RESPONSE TO CONCURRENCE AGENCY INFORMATION REQUEST – SECTION 68, PLANNING ACT 2016 & PART 3, SECTION 13, DEVELOPMENT ASSESSMENT RULES – DEVELOPMENT APPLICATION - RECONFIGURING A LOT - BOUNDARY REALIGNMENT (2 INTO 2 LOTS) - 5712 NEW ENGLAND HIGHWAY, GLENAVEN – LOT 83 & 84 CA311090 (SARA Ref: 2404-39852 SRA, Council Ref: RAL/2024/1294)

Project Name: Subdivision – 5712 New England Highway | Glenaven
Project No: 24E-0188

SARA information request - 5712 New England Highway, Glenaven

Figure 4: Proposed access locations

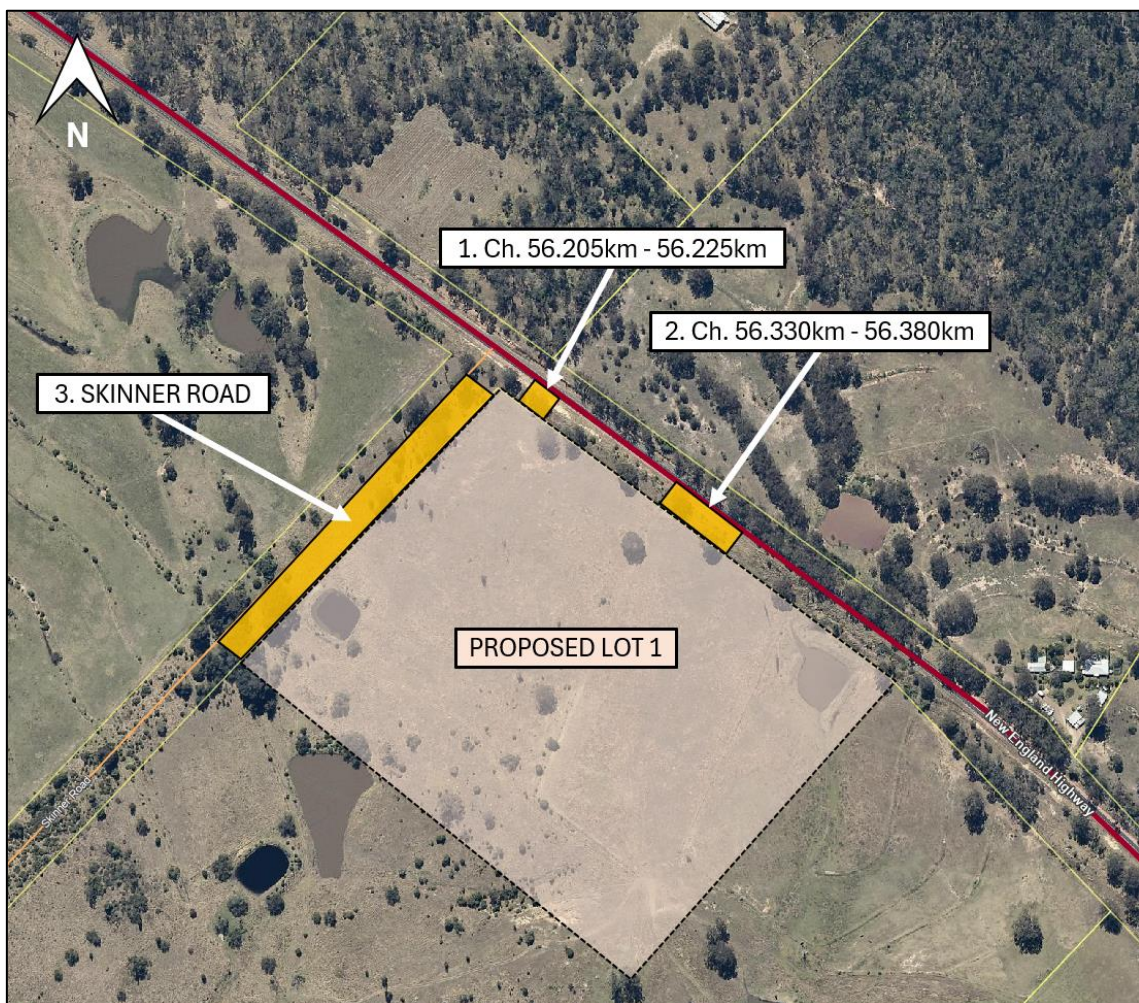
SARA has identified safety concerns regarding the proposed access location of proposed Lot 1 to the New England Highway (a state-controlled road).

The access location to proposed Lot 1 is situated on a section of the highway marked with double barrier lines indicating the extent of restricted overtaking sight distance due to horizontal and/or vertical curves

in the road alignment. The access is therefore proposed in a location that has already been determined to pose a risk to road users due to reduced visibility. The proposed access also appears to be required to be located within an embankment which could potentially limit its visibility to users of the highway and result in reduced sight distances for vehicles entering or exiting this driveway.

1. *Provide information on whether the proposed access to the New England Highway can be feasibly located in an alternative location; or*
2. *If the proposed access cannot be relocated, provide a safety assessment of the proposed access location in accordance with TMR's 'Road Planning & Design Manual' and Austroads' 'Standards for Safe Intersection Sight Distance (SISD) – Sight distance at property entrances'. The safety assessment must be prepared by a suitably qualified RPEQ.*

From a site inspection, three potential access locations were nominated for the proposed Lot 1 site. These locations were identified based on available sight distance, roadside characteristics and constructability (i.e. embankment constraints).

These three potential access locations are illustrated in Figure 4 and consist of:

1. New England Highway (Chainage 56.205km – 56.225km)
2. New England Highway (Chainage 56.330km – 56.380km)
3. Skinner Road

From the evaluation of the three access locations, and as illustrated in Table 1 and Appendix C, the most suitable location for an access to Lot 1 is **Location 2 - New England Highway (Chainage 56.330km – 56.380km)**. This option is the preferred location as it meets all the relevant safety and constructability criteria.

Figure 2: Available sight distance for proposed access location 1 (Ch. 56.205km – 56.225km)

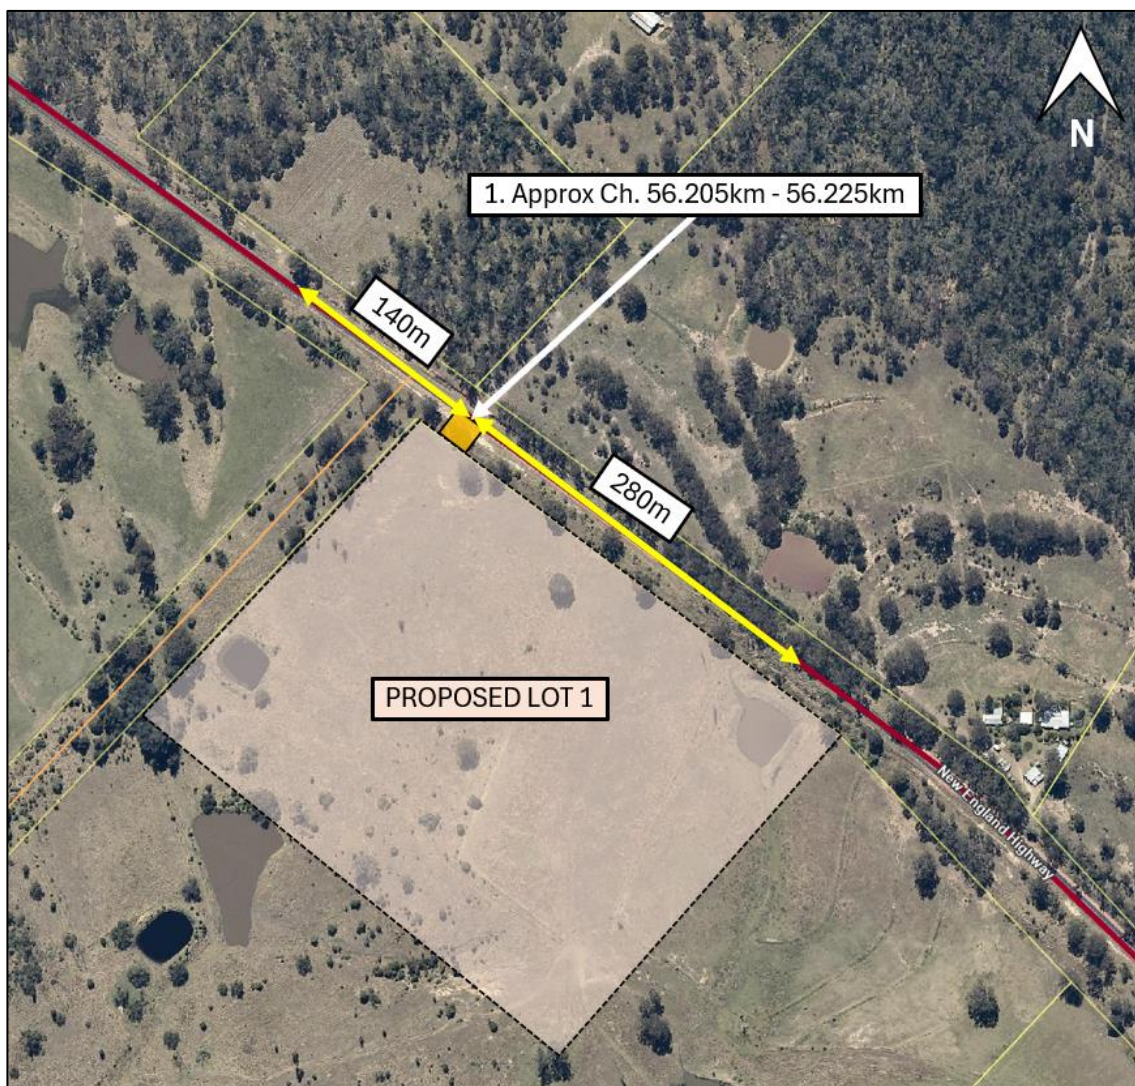
In reviewing dash cam footage captured on-site at a typically driver's eye level (for a car), the available sight distance was estimated at 140m southbound and 280m northbound, as shown in Figure 2.

- All locations do not meet the NDD SISD.
- Access location 1 has deficient Southbound sight distance requirements that generally do not meet the EDD SISD check cases, SSD and MGSD.
- Access location 2 meets all EDD SISD check cases, SSD, MGSD and AS2890.1 requirements
- Access location 3 generally meets most of the sight requirements, however is deficient for the Northbound direction with the EDD Normal Day base case and SSD requirements.

Figure 4: Available sight distance for New England Highway / Skinner Road intersection

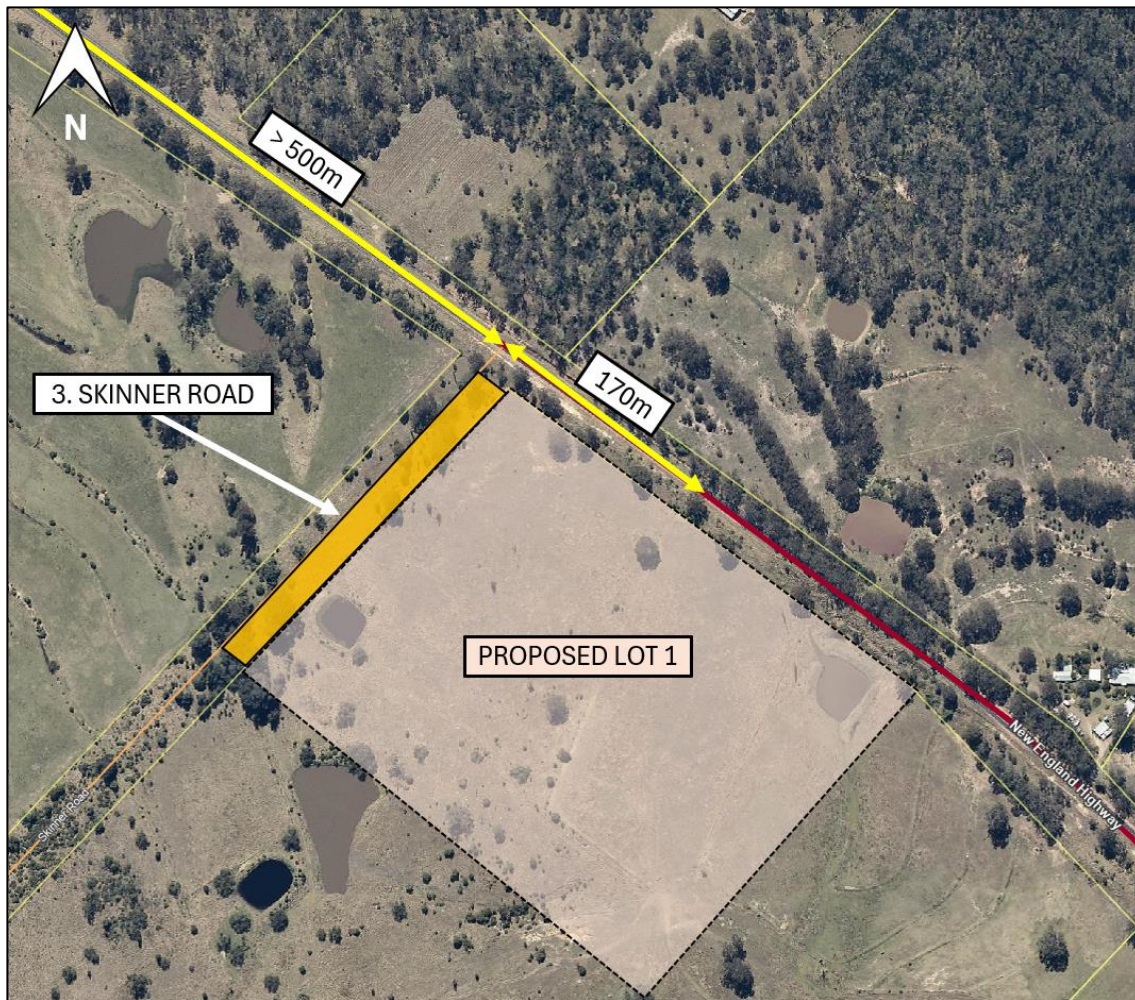
In reviewing dash cam footage captured on-site at a typically driver's eye level (for a car), available sight distance was estimated at 170m northbound and >500m southbound, as shown in Figure 4.
